# SERVICE BULLETIN

No. 527

Piper Aircraft Corporation

Subject: Electric Trim Switch Modification

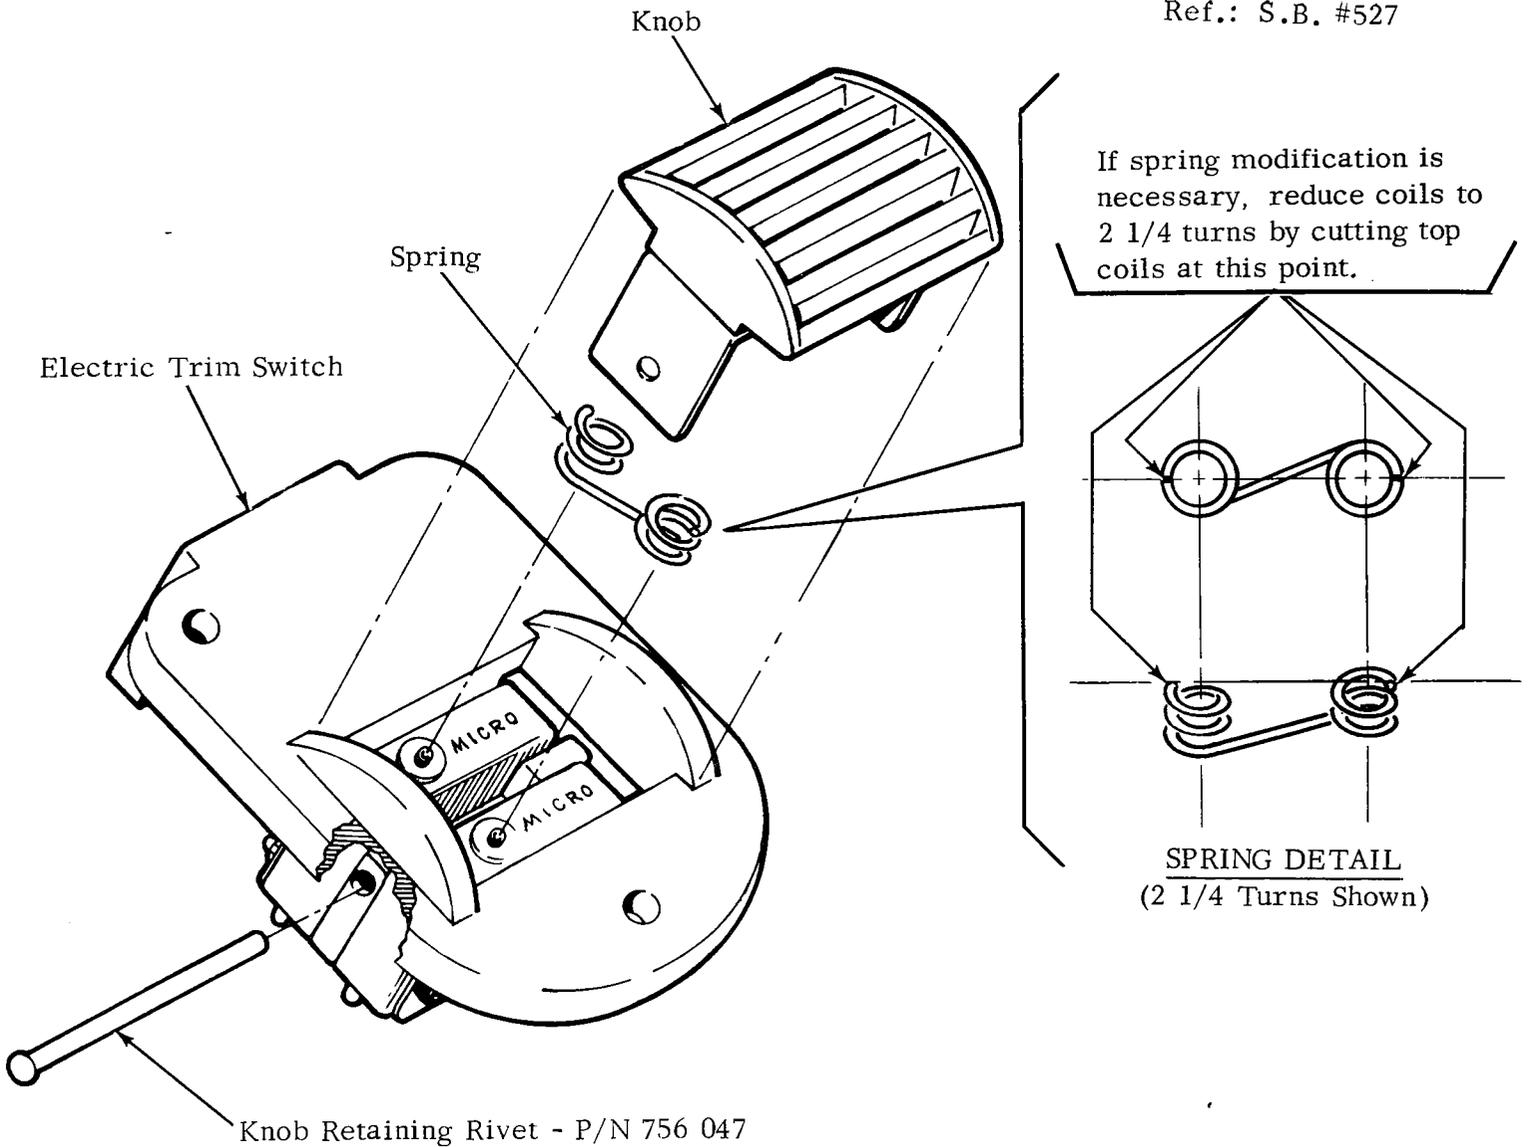
Purpose: Field reports describe a condition wherein the pilot's control wheel mounted "rocker" type electric trim switch tends to "hang up" in the "FWD"/"NOSE UP" or "AFT"/"NOSE DOWN" mode; i.e., fails to return to the "neutral" position following removal of thumb pressure. This condition occurred on some aircraft modified in accordance with Service Bulletin No. 331. Subsequent investigation revealed that the switch return coil springs supplied with Piper Kit No. 760 505 (Electric Trim Switch Modification), per Service Bulletin No. 331 and subsequent production modified models--for a period of time--had an excessive number of coils, which may cause the end of the coil spring to become caught between the switch "rocker" actuator and the micro switch body, thus preventing spring assisted return of the switch to "neutral".

To remedy--and prevent--this condition, this service release provides instructions to modify the electric trim switch return spring by reducing the number of coils (from 2 1/2 turns to 2 1/4 turns--reference attached sketch/instruction sheet for an illustrated view of this condition).

4. Remove knob and spring from switch.
5. Inspect spring to determine if coils consist of 2 1/4 turns as shown in above detail or 2 1/2 turns.
  - a. If coils consist of 2 1/4 turns, proceed to Step 6.

- b. If coils consist of 2 1/2 turns, modify spring by cutting 1/4 turn from top of coils before proceeding to Step 6. Refer to spring detail above.
6. Place spring (P/N 757 685 - Scott #10004324) over micro-switch buttons with open ends of spring facing up. Spring coils must be concentric with micro-switch buttons and shoulders, and must not rest upon them.

7. Place knob in position and depress slightly so that the new retaining rivet (P/N 756 047 - Scott # 36270) can be installed. Take care not to dislodge spring from position.
